Access Compliance Report

Public Rights-of-Way

(Curb Ramps)

Intersection ID: 29777	Main Street: REA_RD	Cross Street: WILLIAMS_POND_LN	Location: S
ADA ID: AD7A332BAEED	Ramp Type: Perp	Initial Pass/Fail: Fail	Overall Compliance: No
			Severity Score: 21.25

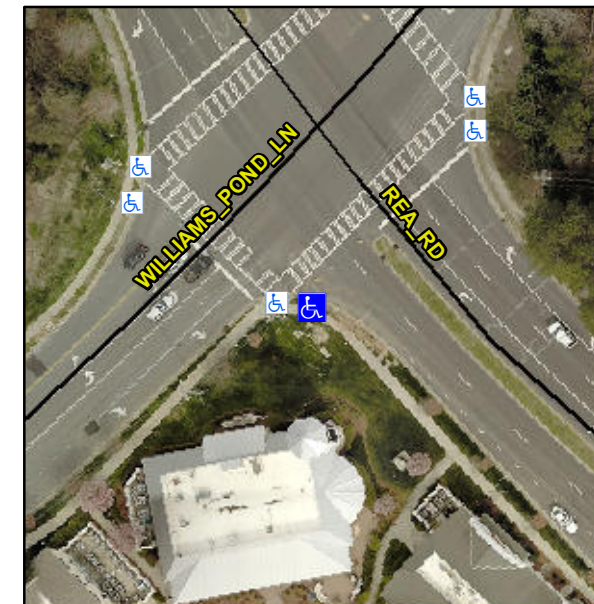
Not Found, R304.5.1, R304.2.2

Compliance	Description	Data	Compliance	Description	Data
N/A	Ramp Length (in)	101.0	No	Ramp Slope (%)	8.7
No	Ramp Width (in)	47.5	Yes	Ramp XSlope (%)	0.9
N/A	Flare Type LT	N/A	N/A	Flare Type RT	N/A
N/A	Flare Slope LT (%)	N/A	N/A	Flare Slope RT (%)	N/A
N/A	Flare Traversable LT?	N/A	N/A	Flare Traversable RT?	N/A
N/A	Landing Length (in)	N/A	N/A	DWS Provided?	N/A
N/A	Landing Width (in)	N/A	N/A	DWS Contrast?	N/A
N/A	Landing Slope (%)	N/A	N/A	DWS Length (in)	N/A
N/A	Landing X Slope (%)	N/A	N/A	DWS Full Width?	N/A
N/A	Landing Curb? (Y/N)	N/A	N/A	DWS Offset (in)	N/A
N/A	Shared Landing?	N/A			
N/A	Gutter Ponding?	N/A	N/A	Gutter Slope (%)	N/A
N/A	Gutter Lip Ht (in)	N/A	N/A	Gutter X Slope (%)	N/A
N/A	Painted X Walk1?	Yes	N/A	Painted X Walk2?	N/A
	X Walk 1 Direction	To NE		X Walk 2 Direction	N/A
N/A	X Walk 1 Width (in)	108.0	N/A	X Walk 2 Width (in)	N/A
	X Walk 1 Slope (%)	5.0		X Walk 2 Slope (%)	N/A
	X Walk 1 X Slope (%)	1.1		X Walk 2 X Slope (%)	N/A

N/A	Ramp inside XWalk1?	No	N/A	Ramp inside XWalk2?	N/A
	Road Slope (%)	N/A	N/A	Clear Space?	N/A
	Road X Slope (%)	N/A	N/A	Clear Space to XWalk (in)	N/A
N/A	Any Obstructions?	N/A	N/A	Storm Grate/Utility Hazard?	N/A
	Obstruction Type			Storm Grate/Utility Type	
		N/A			N/A
			Yes	Surface Condition? (G/P)	Good

**Remove & Replace Entire Ramp.
Restripe Crosswalk.**
